CITY OF KIRKLAND
Planning and Community Development Department
123 Fifth Avenue, Kirkland, WA 98033 425.587-3225
www.ci.kirkland.wa.us

MEMORANDUM

Subject: PLAZA AT YARROW BAY OFFICE BUILDING ZONING AND PUD PERMITS,
PCD FILE NO. ZON08-00017

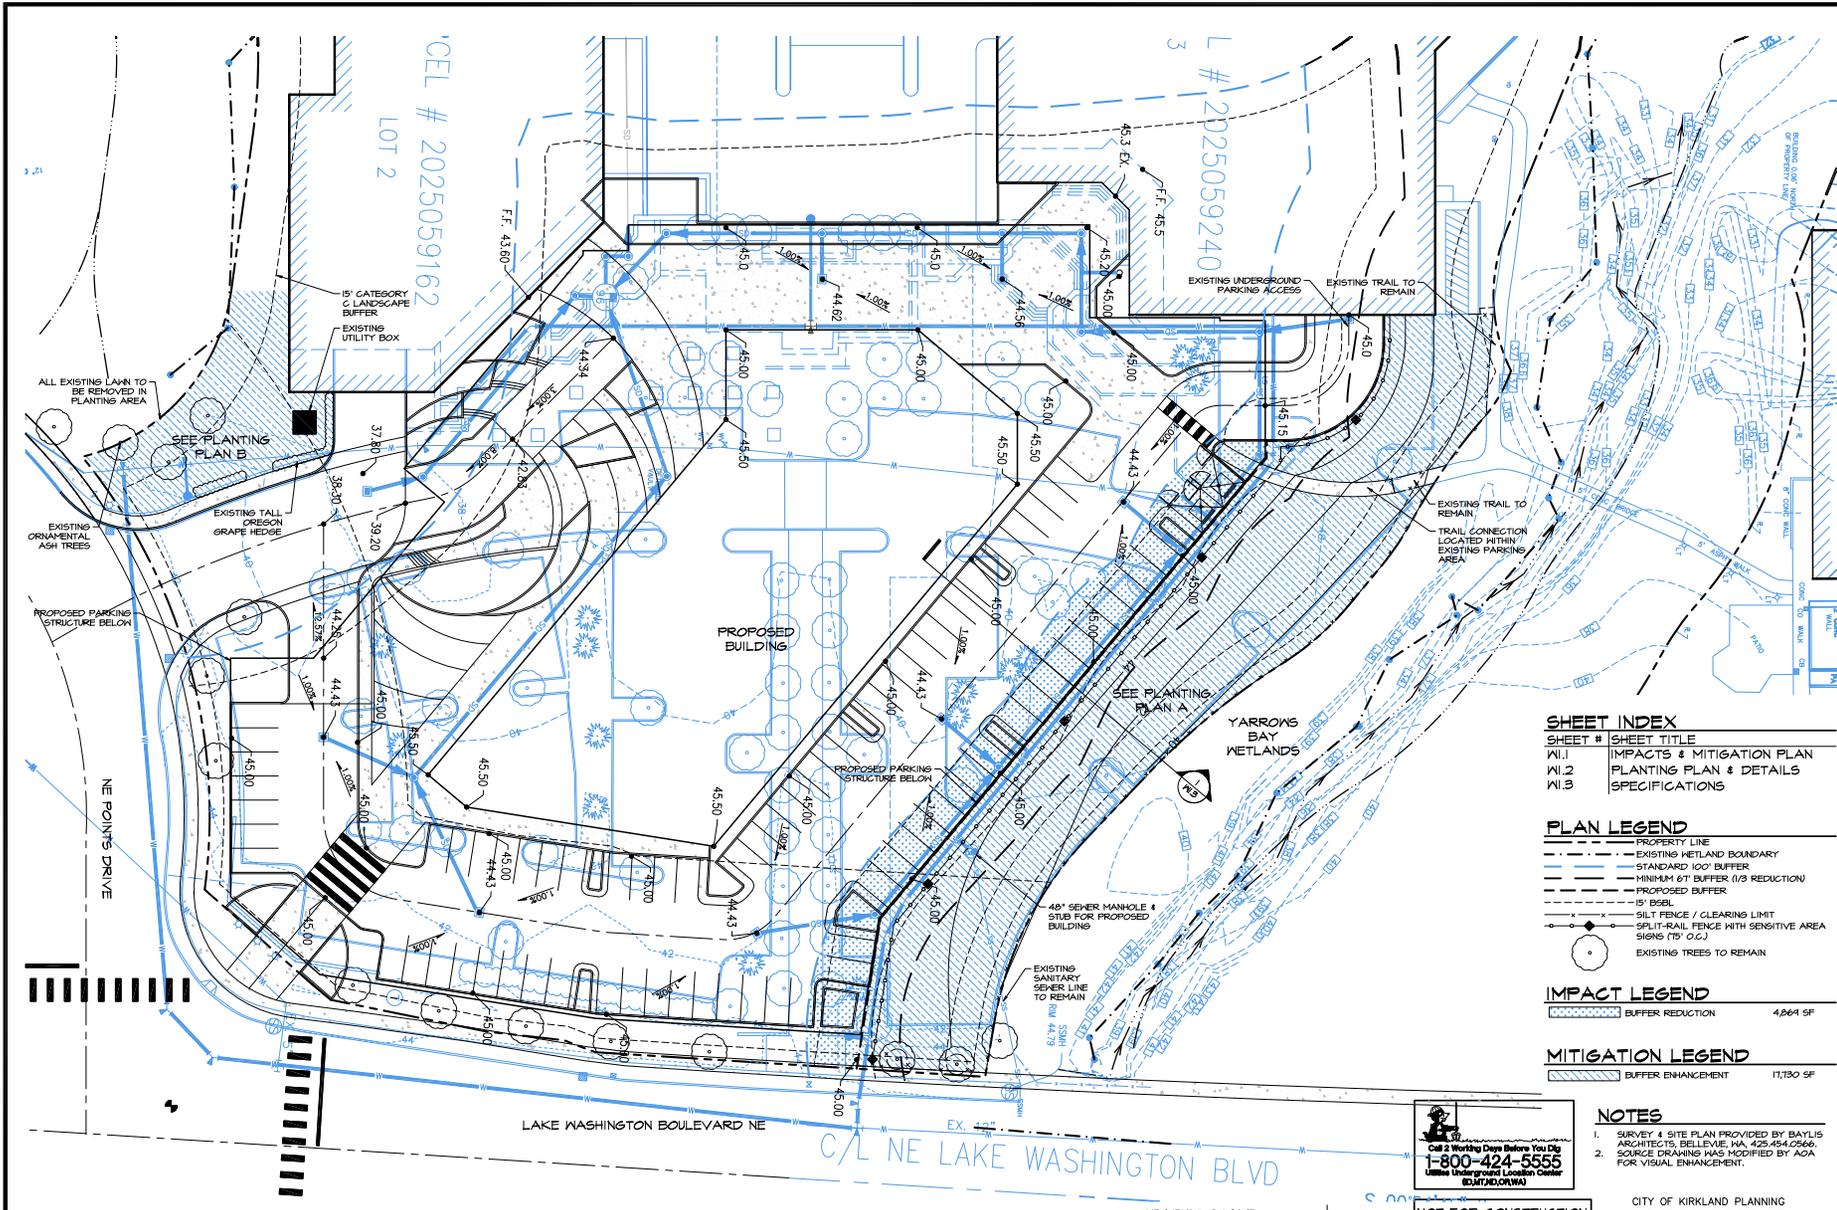
Similarly, Sheet W1.1 shows another storm water line running from Lake Washington Boulevard west through the planted buffer and ending at an intersection of two other storm water lines just west of the proposed new building staircase. Will this line be removed, retrofitted, or decommissioned? If it must remain in the buffer, will proposed large trees cause future maintenance or damage problems?

Portions of the area covered by Planting Plan B (Sheet W1.2) are currently maintained lawn. Is the intent of this plan to eliminate lawn in this area? If so, this detail should be added with specifics on how lawn is to be eradicated. Also, proposed plant density is likely not high enough to compete with lawn grasses and other weeds and meet specified performance standards. Area-wide mulch will assist in preventing reemergence of lawn grasses.

The cutting installation detail on Sheet W1.2 contains illegible text that appears to be a text formatting problem.

- 7) Reformat or otherwise clarify text accompanying detail 4 on Sheet W1.2.
- 8) Provide an itemized bond quantity estimate for review. The estimate should include all installation costs plus costs associated with monitoring and maintenance for the five-year establishment period.

6. The specifications were revised to include survey and permanent staking of the boundary of the property line between Planting Plan A and the City's restoration project. See Part 1 – Survey / Stake / Flag Limits of Clearing and Property Line on Drawing W1.3.

7. This detail was revised.
8. The bond estimate was provided.
